Amendments to the Drawing

REMARKS

Status of Prosecution

FIGURES 4-5 OF MURRAY PATENT

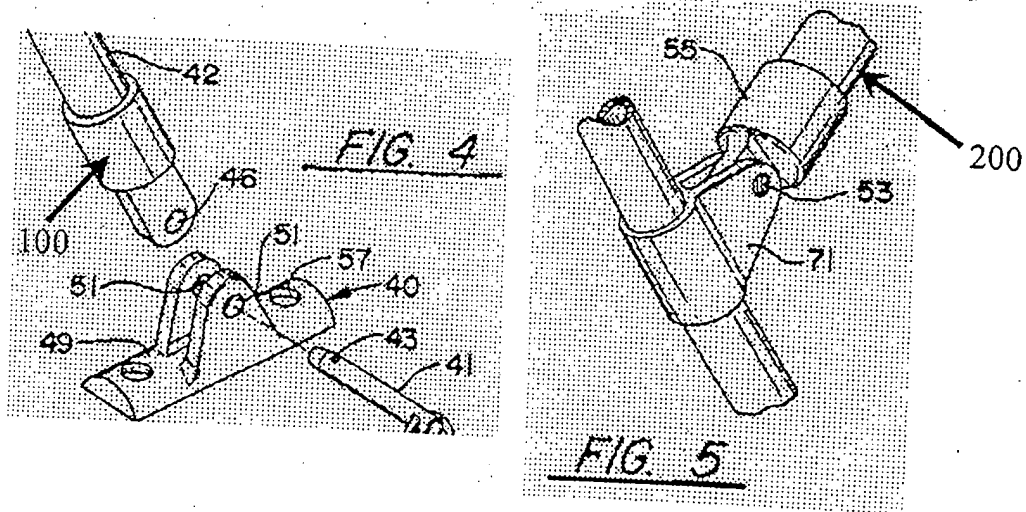
30 The apparatus of the Murray Patent is not universally adjustable. As is evident from the marked-up figures shown by the Examiner on page 4 of the Office Action, and reproduced on page 20 of this Reply, the component that the Examiner labeled “tub 100” allows leg 42 to be
positionable in one plane only. Together, components 42 and 100 may rotate only in one plane around the axis formed when quick release pin 41 is inserted through apertures 52 (see Figures 4-5 of the Murray Patent, and column 3, lines 58-64).

20 B. Structural Disagreements Marked-up Figures 4 and 5 from the Murray Patent are reproduced for an additional reason. In the earlier Reopened Office Action the Examiner stated that Applicant "does not fully appreciate that figures 4 and 5 show separate sections of the assembly of figure 1." The Examiner went on to state: "Figures 1, 4 and 5, as depicted together above, show that element 100, while similar in structure to element 55, is in addition to and
25 assembled away from element 55." (Emphasis added.) Applicant respectfully disagreed then, and raises this again to show how the structure and cooperation of structure of the Murray Patent and Applicant's coupler are completely different.

Element 100 and element 55 are identical, not similar, in structure; that the differences in structure occur in connection with the configuration of the substrate on which component 100
30 and component 55 are mounted. Thus, component 100 is mounted on base 49 having a flat

planar surface, whereas component 55 is mounted on a tube formed with T-fitting slides 71. Again, the structural difference resides in the different substrates, not in component 100 and component 55.

Also germane is the fact that under no interpretation of the components of the Murray apparatus can either Figure 4 or Figure 5 be construed to show the tub and plug of Applicant's apparatus, an argument made clear in subparagraph C. below.

1. The marked-up figures from the Murray Patent confirm that the underside of base 42 is flat. The Examiner concedes that the underside of base 42 is a "flat planar surface." See Office Action, page 4. A flat planar surface is not designed for mounting on a curved

FIG. 5

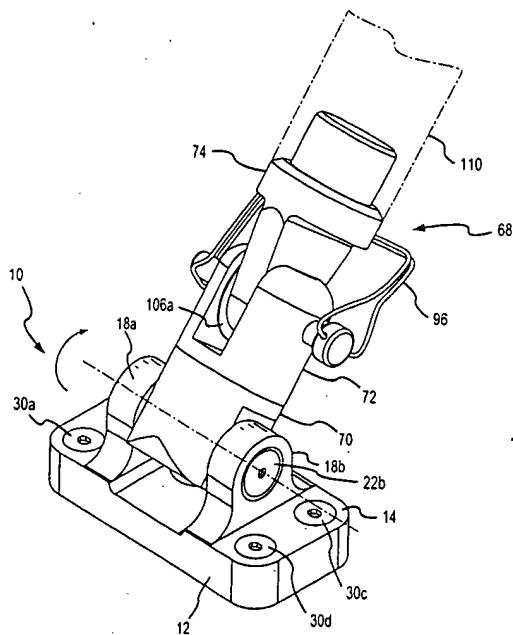
In Figure 5 a reference character “68” was deleted.

Figure 5 is a perspective view of the coupler showing possible variable positions;

B. Drawing Figures. On page 2 of the Office Action the Examiner objected to reference characters in drawing figures 3, 4, 5 and 8A-8B. Applicant encloses with this paper replacement drawing figure sheets in response to the objections except for the objection to reference characters “36” and “40” in Figure 3.

FIG. 6

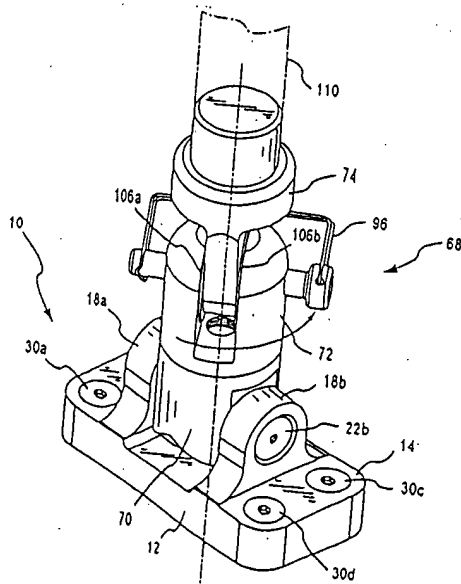
Figure 6 is a perspective view showing yet another of the variable positions of the coupler;

5 For Example, Figure 6, however, begins to demonstrate the mechanical departure of the coupler from the Murray apparatus. The semi-circular arrow shown on plug 72 of coupler 10 shows yet another of the variable positions of the coupler by showing that because of the unique use of plug 72 in combination and mechanical cooperation with neck 74 and tub 70, components of coupler 10 may also and simultaneously rotate around a y-axis. Figure 7 shows that a
10 segmented portion of coupler 10, namely neck 74, may rotate around yet another z-axis. As indicated in the "Brief Description of the Drawing," Figure 8A shows that tub 70 may rotate around the axis formed by first threaded bolts 22a,b in opposing yokes 18a,b, while at the same time plug 72 may rotate in relationship to tub 70, while at the same time neck 74 may be variably positioned in yet another plane or direction -- all of which is shown again for emphasis from an

FIG. 7

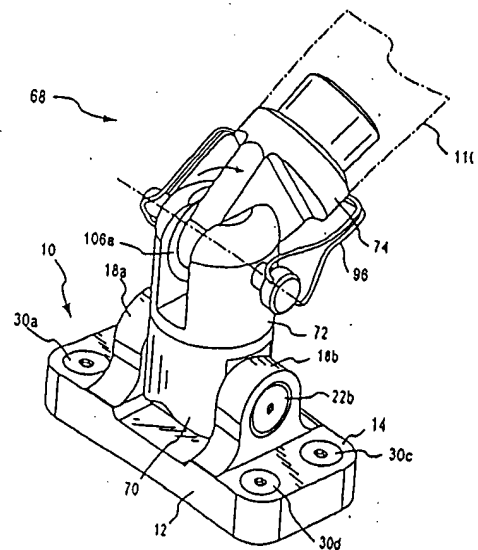
Figure 7 is a perspective view showing another variable position of the coupler;

FIG. 8A

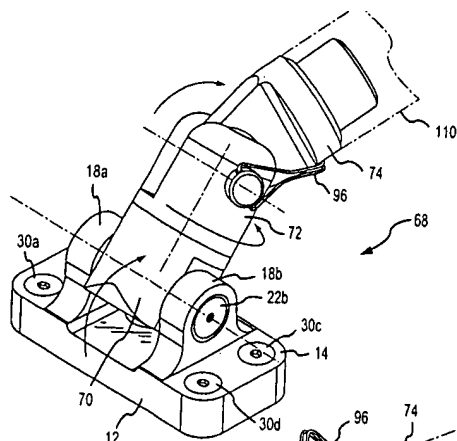
In Figures 8A and 8B reference character “10” was deleted.

Figure 8A is a perspective view showing another variable position of the coupler;

FIG. 8B

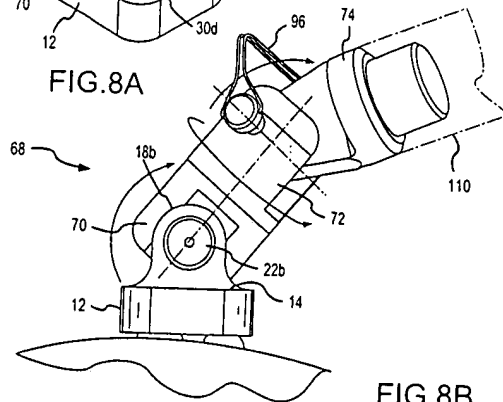
Figure 8B shows another variable position of the coupler on the ball washers...

15 alternative perspective in Figure 8B, which also demonstrates graphically that the flat bottomed base 12 is securely fastenable to a curved surface through the use of the ball washer assemblies 40.
